FORM APPROVED
OMB NO. 1004-0137
Expires: January 31, 2018**SUNDRY NOTICES AND REPORTS ON WELLS**
*Do not use this form for proposals to drill or to re-enter an abandoned well. Use form 3160-3 (APD) for such proposals.***SUBMIT IN TRIPLICATE - Other instructions on page 2**

1. Type of Well ☒ Oil Well ☐ Gas Well ☐ Other		5. Lease Serial No. NMNM0531277
2. Name of Operator MEWBOURNE OIL COMPANY		6. If Indian, Allottee or Tribe Name
3a. Address P O BOX 5270 HOBBS, NM 88241		7. If Unit or CA/Agreement, Name and/or No. 891012406C
3b. Phone No. (include area code) Ph: 575-393-5905		8. Well Name and No. FORTY NINER RIDGE UNIT 105H
4. Location of Well (Footage, Sec., T., R., M., or Survey Description) Sec 22 T23S R30E SESE 525FSL 666FEL		9. API Well No. 30-015-44219-00-X1
		10. Field and Pool or Exploratory Area FORTY NINER RIDGE
		11. County or Parish, State EDDY COUNTY, NM

Mewbourne Oil Company has an approved APD for the above well. Mewbourne requests approval to make the following changes:

Mewbourne Oil Company, Forty Niner Ridge Unit #105H

13-5/8" MN-DS Wellhead System

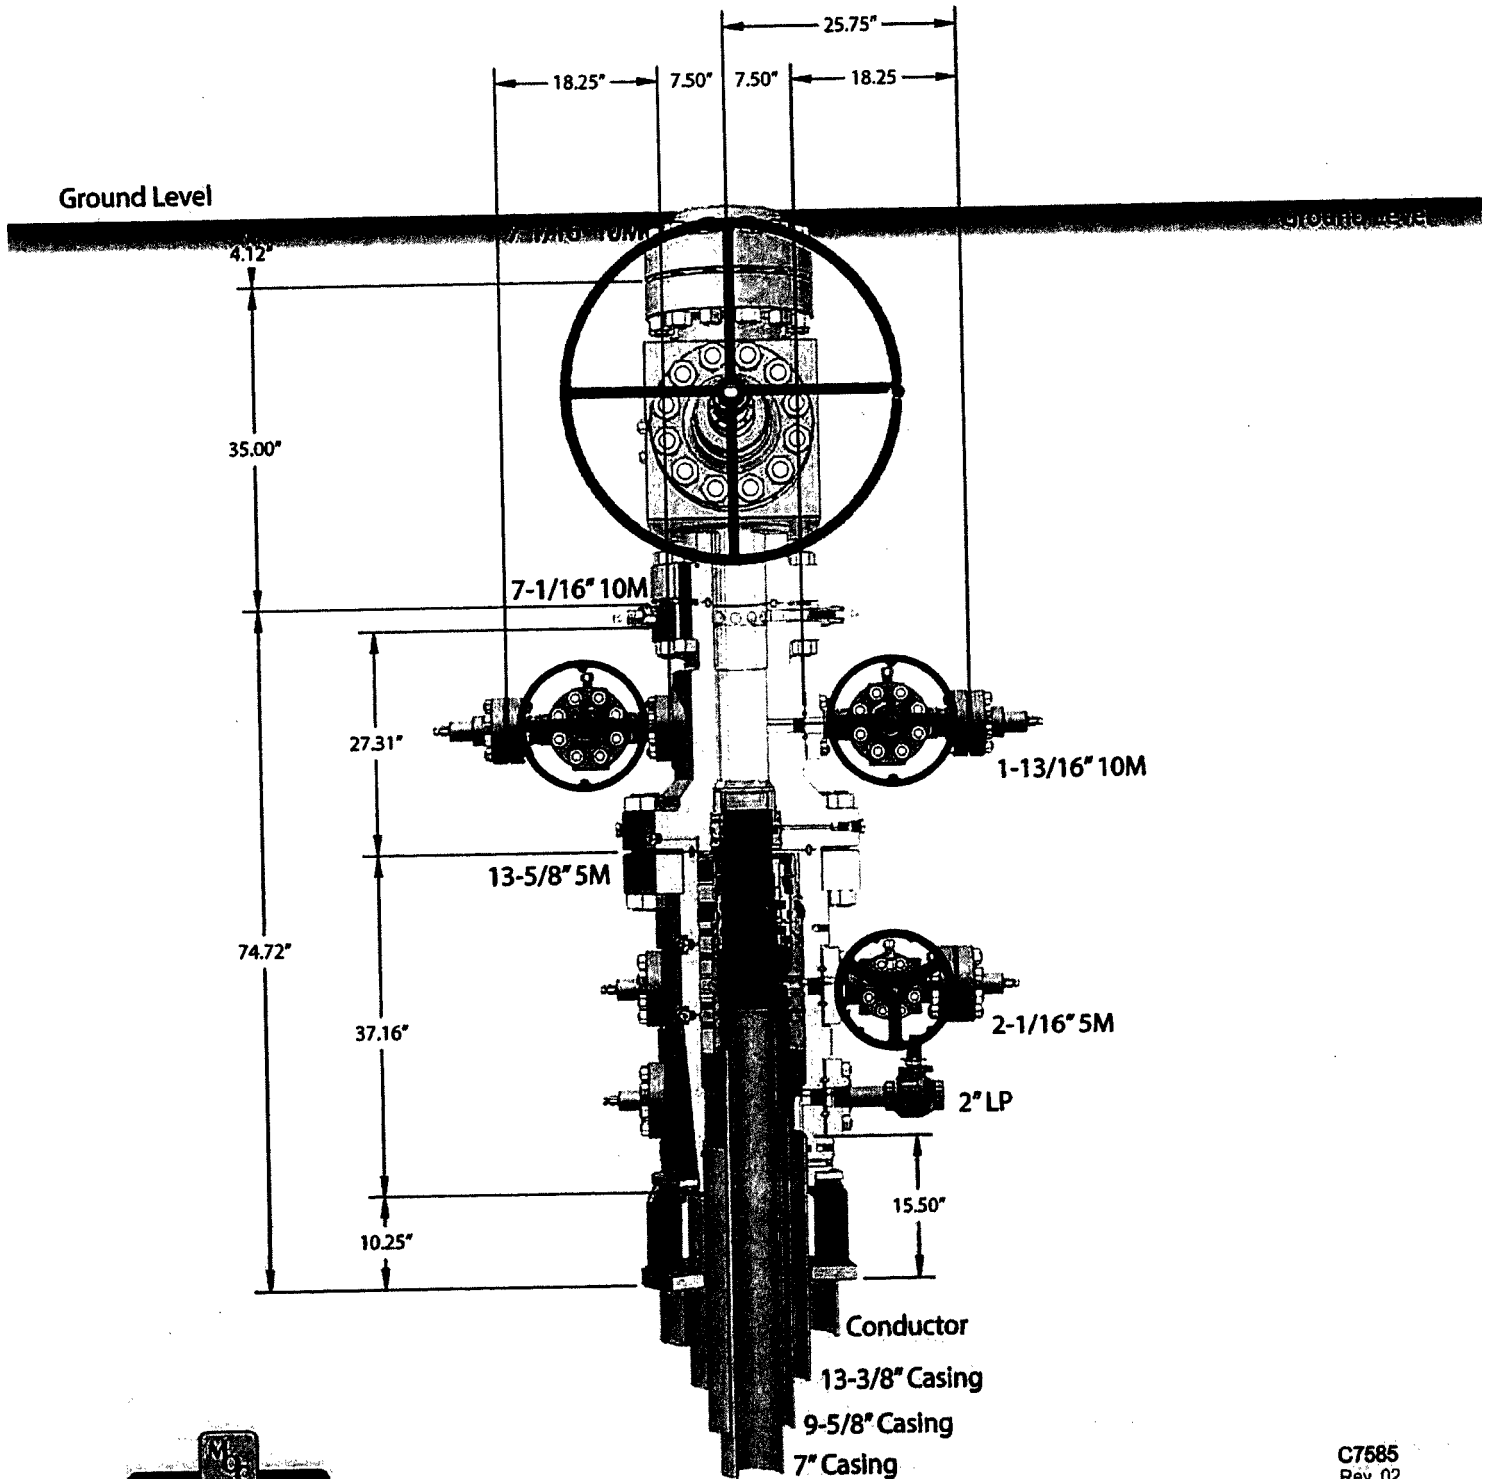
- 1) Change SHL to 525' FSL & 445' FEL, Sec 22, T23S, R30E.
- 2) Change BHL to 100' FNL & 330' FEL, Sec 15, T23S, R30E.
- 3) Change 7" x 5 1/2" split production casing to 7" production casing with 4 1/2" cemented liner.
- 4) Change cement to suit new casing.
- 5) Change wellhead to multi-bowl type wellhead.

Please see attachments for wellhead schematic, new drilling plan, casing & cement information..
